RIVER ROCK RANCH
MASTER DEVELOPMENT PLAN

March 19, 2007

Re: River Rock Ranch **MDP # 036-06**

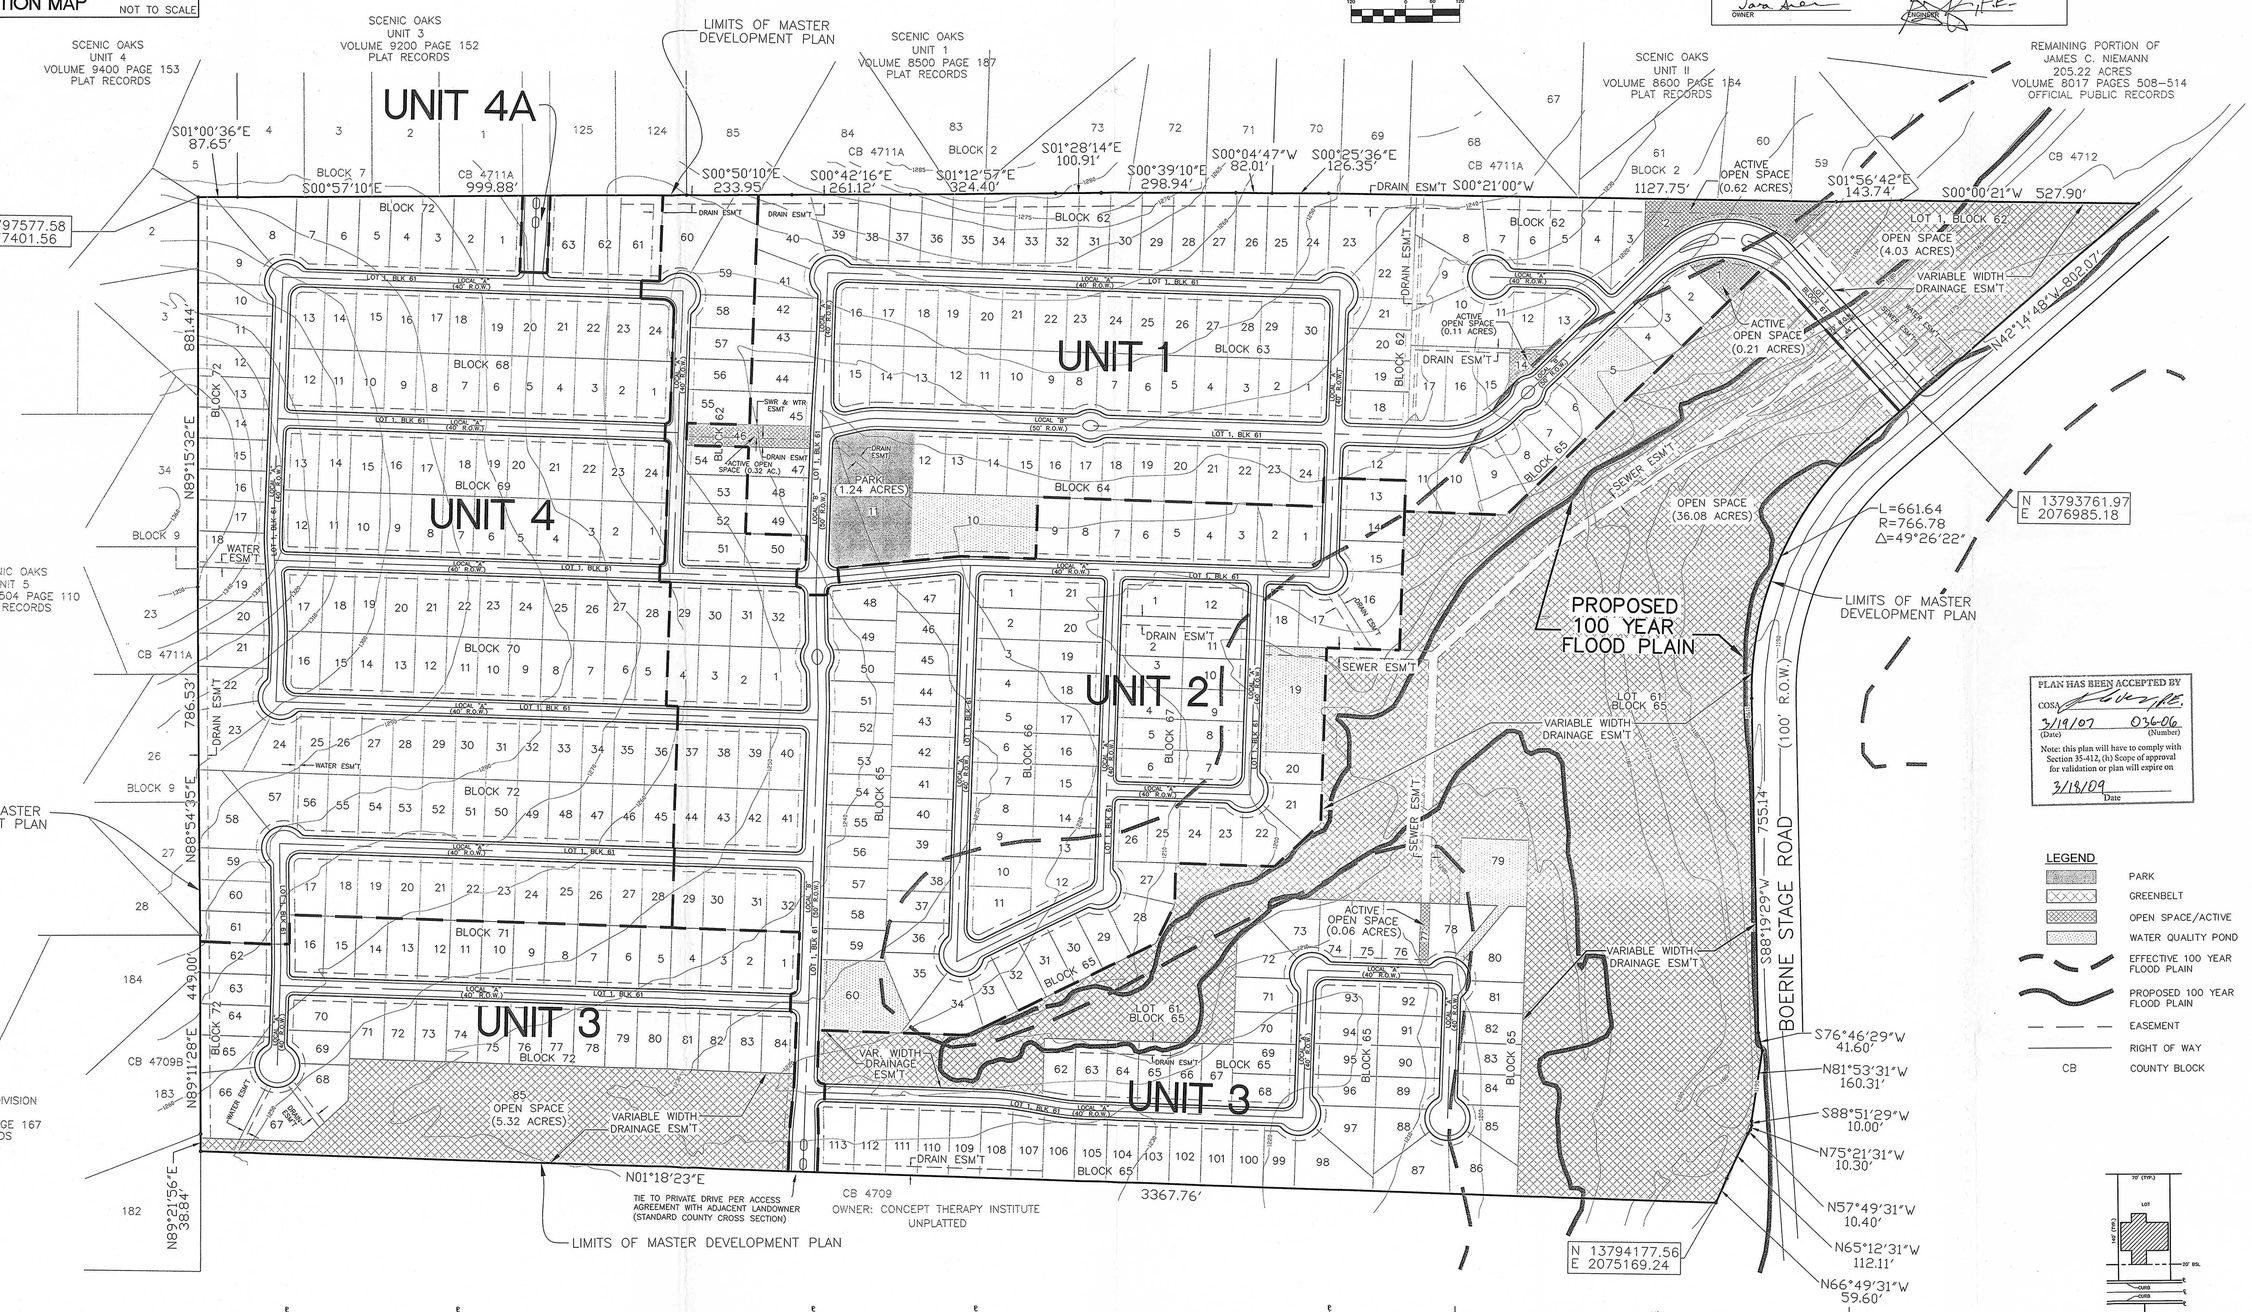
In consideration of public safety and convenience, excessive grades by reason of topography should be avoided in street layouts and arrangements. Any access and ROW issues along state facilities will need to be resolved with the **Texas Department of Transportation (TXDOT)**. For information about these requirements you can contact TXDOT at 615-5814.

- All access driveways shall comply with UDC 35-506(r).
- All roadways shall conform to Table 506-2 Functional Classification System Description for Traditional Design Classification.
- All sidewalks shall comply with UDC 35-506(q).
- All access roadways shall provide clear sight distance on all existing and proposed roadways in order to provide adequate obstruction free viewing distances for approaching traffic. All signage, landscaping, and improvements shall be selected and located so as to not block these clear sight distances areas.
- The developer shall be responsible for providing right-turn deceleration lane, with storage lengths and bay taper in all the driveway access point approved by TxDot as it relates to the submitted TIA, UDC 35-506(d) Driveway #1.

- The parkland provided shall be shown as "Park" or "Open Space" on a plat; UDC section 35-503(e) *Designation of Parkland.*
- The parkland provided shall be dedicated to the Homeowners Association.
- The instruments creating the Homeowners Association shall be provided by the second application for plat approval; UDC section 35-503(e) *Designation of Parkland.*
- Parkland dedication shall be platted by the second phase of development; UDC section 35-503(f) *Development Phasing.*
- All amenities provided shall comply with standards and specification found in UDC section 35-503(h) *Credit for Park Facilities* and Table 503-4 if any credit is to be awarded.

- 100 year Flood Plain Shown and Buffering (If applicable)
- Significant Recharge Features and Buffering (If applicable)
- Category Letter for All Site Specific Plats (If Category 2 or 3, an Aquifer Protection Plan is required (If applicable)
- Additionally, a Water Pollution Abatement Plan or Contributing Zone Plan must be submitted to and approved by the Texas Commission on Environmental Quality (TCEQ) prior to construction.

- According to the Aquifer Protection Ordinance# 81491, Section 34-914, floodplain buffering may be required. Any existing wells located on the property shall be plugged. For plugging procedures, please contact Kirk Nixon at 233-3523.

- Traffic controls shall be warranted as per the Texas Manual on Uniform Control Devices and approved by Bexar County.
- Add a westbound right-turn deceleration lane at the sites main entrance on Boerne Stage Road through a separate permit from Bexar County.
- Upgrade and maintain a minimum county road section through the Concept Therapy Institute property as per the written agreement submitted with this Master Development Plan.
- Secondary access must be finalized prior to the approval of any plat or combination of plats exceeding 125 dwelling units as per UDC 35-506(e)(7).
